## Product Change Notice

Introduction of replacement die for below part numbers.

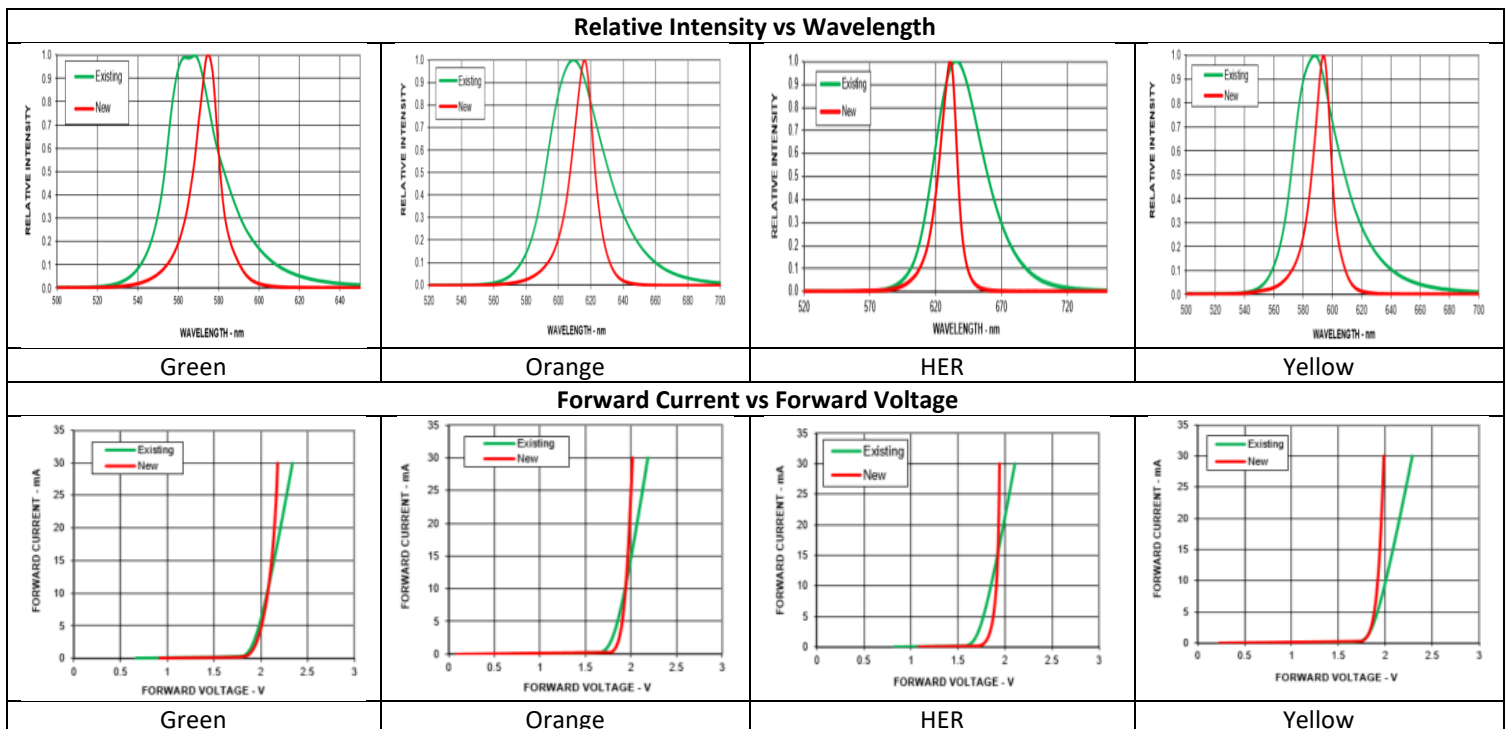
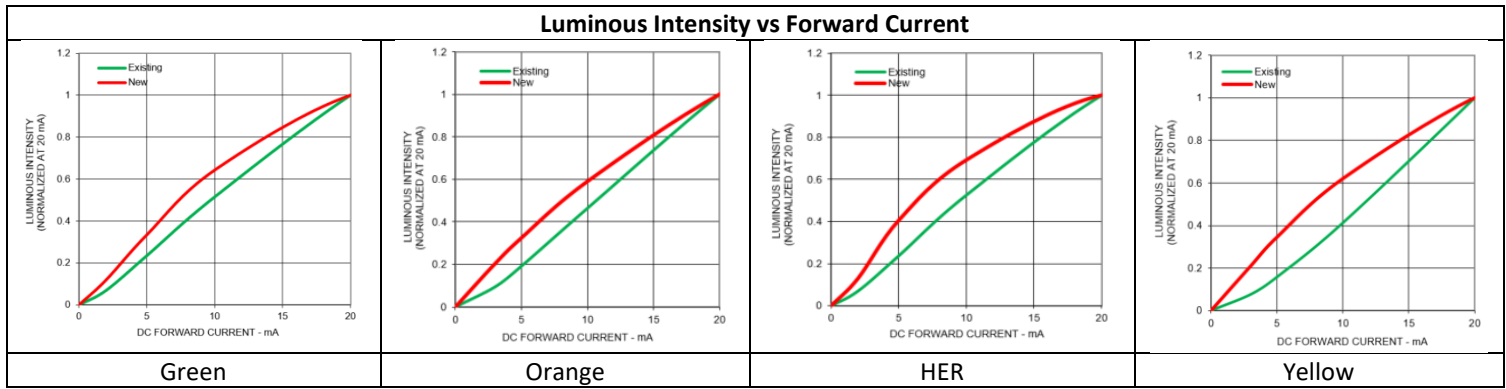
The new die (AlInGaP) will replace the existing die (GaP) for all affected part numbers. The new die (AlInGaP) is qualified per Broadcom's qualification process.

Following are the changes in product characteristic,

1. Relative Intensity vs Wavelength
2. Forward Current vs Forward Voltage
3. Luminous Intensity vs Forward Current
